# UNITED STATES PATENT AND TRADEMARK OFFICE

## Office Action Summary

10/643,862

## **DETAILED ACTION**

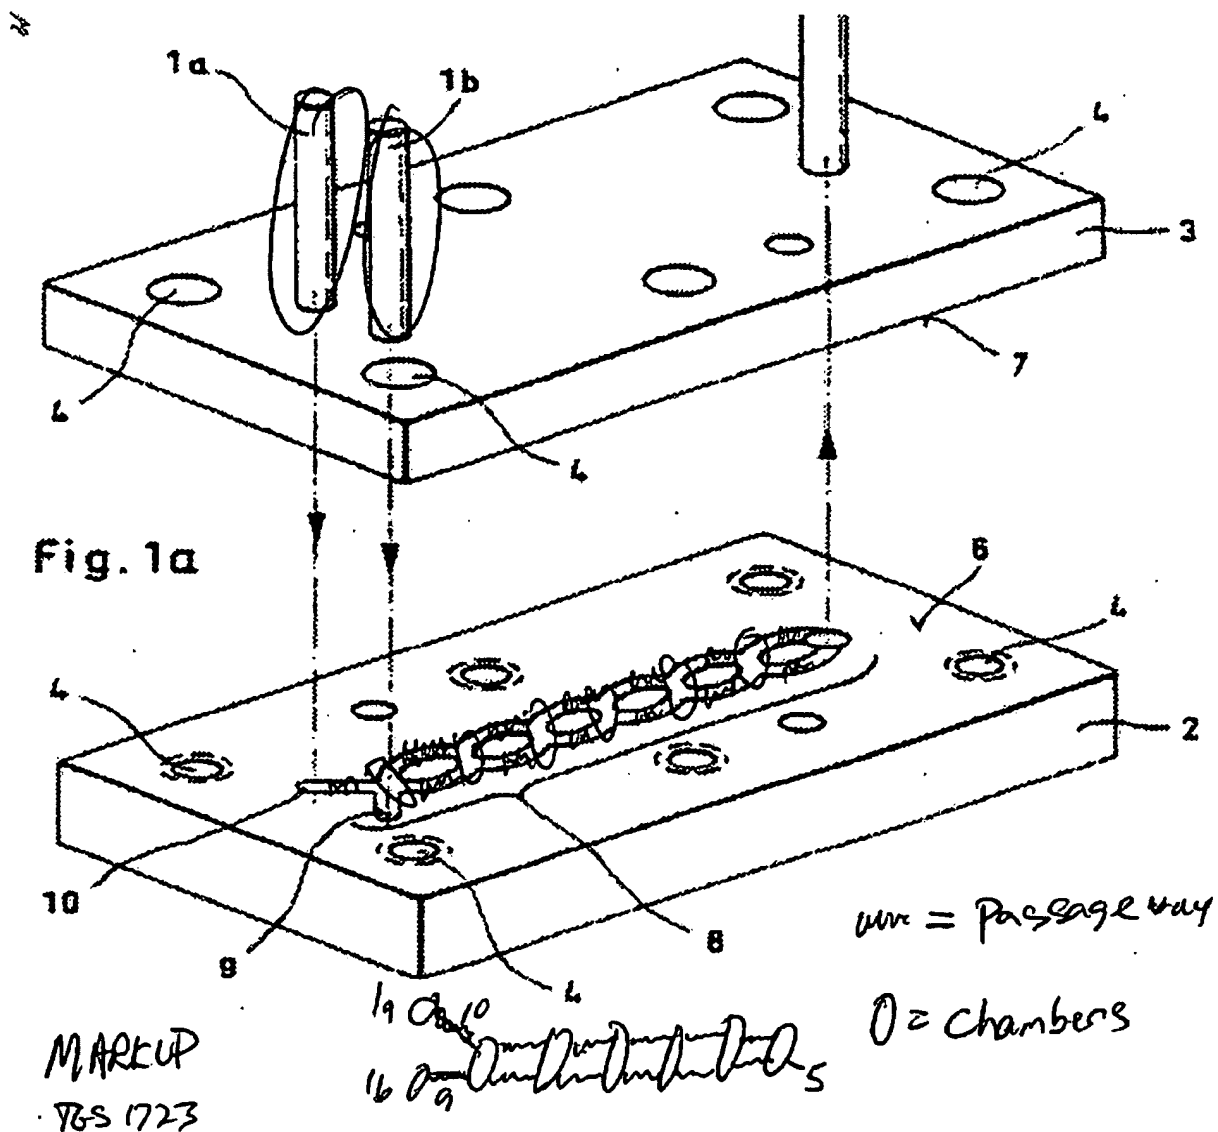
5. Claims 1-2, 4, 20, and 21-22, and 24, are rejected under 35 U.S.C. 102(e) as being anticipated by Koop et al US 6457854 (cited on PTO 1449).

The Koop reference discloses an apparatus and method of use for mixing fluids including two inlets for a 1<sup>st</sup> and 2<sup>nd</sup> fluid wells to be fed into a 1<sup>st</sup> chamber at the intersection of 9,10, a second chamber through seventh at the intersection of the sinusoidal loops which are microchannel capillary passageways along the portion 8, see figure 1, which ends at an outlet chamber at 5 for further processing, whereby each loop side may be deemed as separated passageways. It is noted that one may define any subsequent volume of liquid dispensed from the source wells 1a and 1b as a volume per unit time to be mixed together and one may deem the time unit so small that

11. Applicant alleges that the Koop reference does not show 1<sup>st</sup> and 2<sup>nd</sup> chambers connected through capillary passage ways. Applicant is referred to the rejection made above in section 5 and refer to the mark up drawing.
